SUBJECT: Statutory Public Meeting and recommendation – 420 Guelph Line official plan amendment and rezoning applications

Report Number: PL-49-20

File Numbers: 505-01/20 and 520-02/20

Refuse the application for official plan and zoning by-law amendments submitted by Weston Consulting, on behalf of Valour Capital Inc. for the development of a 13-storey residential building on the property located at 420 Guelph Line.

APPENDIX B

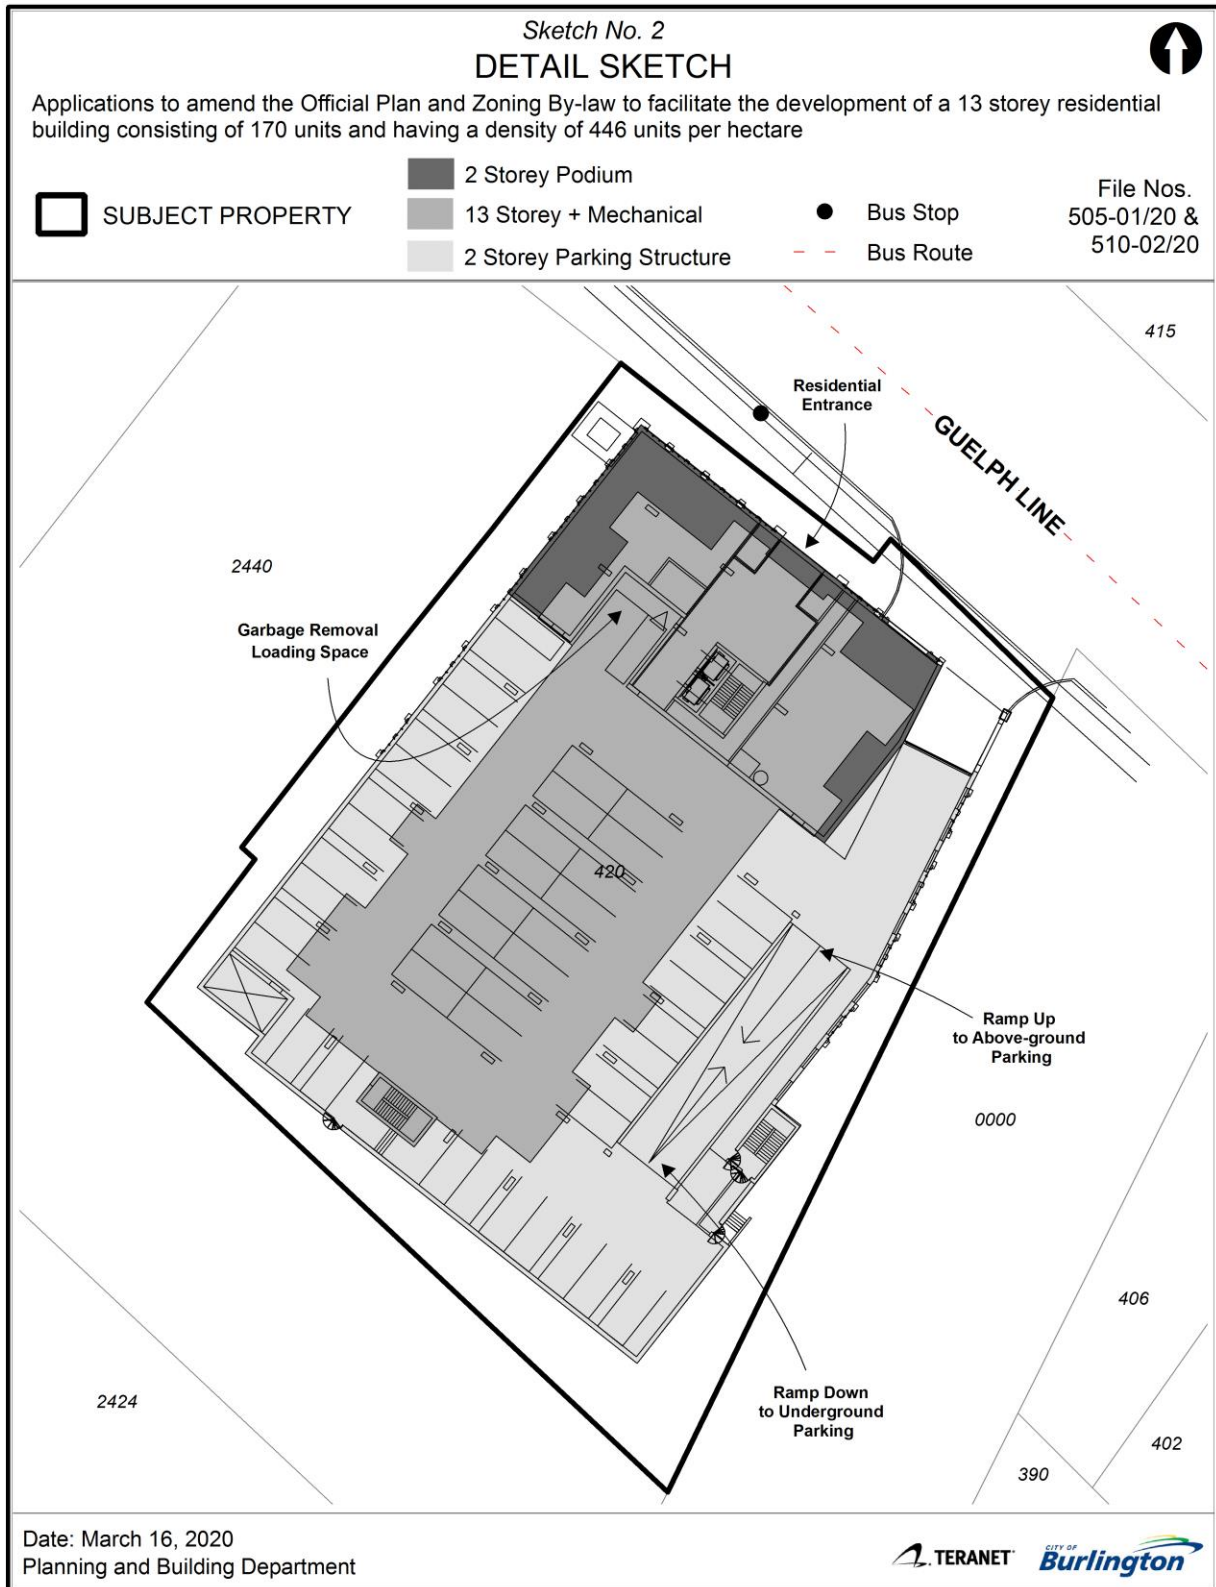
The applicant is proposing to rezone the lands to “Residential – High Density (RH4)”. This zone requires setbacks based on the building size and height. The front yard setback requirement is 7.5 metres plus 1 metre for each storey above 6 storeys. In this case, the minimum setback requirement would be 14.5 metres. The applicant is proposing a front

yard setback of 2.4 metres at the base of the building and 7.9 metres at the top of the building.

The side and rear yards for buildings greater than 30 metres are half of the building height plus an additional metre for each 5 metres that the building length exceeds 30 metres. It is not clear what the building length is; however, half the building height alone requires a 23 metre setback. The applicant is proposing rear and side yard setbacks of 2.6 metres at the closest point.

Staff are of the opinion that the proposed setbacks do not contribute to a development that is compatible with the surrounding area. The setback reductions may also impact the potential for future redevelopment of the lands to the north, which will be discussed further in this report. The setbacks should be increased to allow more space on the site to facilitate landscaping, screening, greenspace and to reduce the impact on nearby properties and the streetscape. This could be achieved by reducing the floorplate sizes which are not supported by staff and reducing the building mass.

The proposed lot coverage for the site is 74.1%. The site does not have space to accommodate commercial uses or outdoor amenity area at the ground level, which is currently to be used primarily for parking. To exacerbate this concern, the applicant is requesting reductions in development standards such as setbacks to accommodate an increased building size. Staff is of the opinion that the proposed building is too large for the site, and that the site layout is not appropriate. Reducing the size of the proposed building, the number of proposed units would also reduce the parking requirement would assist in achieving a more appropriate lot coverage.

As per the discussion of Official Plan Policy 2.5.2 a) ii) in this report, sufficient parking has been provided to support the proposed use. However, the proposed parking configuration is not appropriate on the site and the location of parking at the ground level and second storey is inappropriate given the Neighbourhood Commercial designation of the property. Active uses such as commercial/retail uses would be preferred at grade to activate and animate the streetscape. The proposal has exchanged conformity with a number of other objectives and regulations as outlined in this report in order to meet the parking requirement.

Staff are of the opinion that while the parking complies with the numerical requirement, it must be assessed within the context of the proposal as a whole and in this case, the location and layout is not appropriate.

The applicant is proposing a setback from Guelph Line of 2.4 metres (from the property line) with slight stepbacks as the building height increases. Based on the plans provided, it appears to achieve the 6 metres measured from the curb face. No streetwall is currently established along this section of Guelph Line. The Zoning By-law requires a front yard setback of 7.5 metres measured from the property line, with an additional metre for each storey above 6 storeys. Staff are of the opinion that a greater setback would be more appropriate in this location.

The proposed development does not provide 12.5 metre setbacks to the rear or side property lines. The property is adjacent to a trail on the south and one property wraps around the north and west sides of the site. As such, there are not concerns with potential future tower separation for the lands to the west and the south; however there are concerns that the development potential of the lot on the southwest corner of Guelph Line and New Street may be compromised.
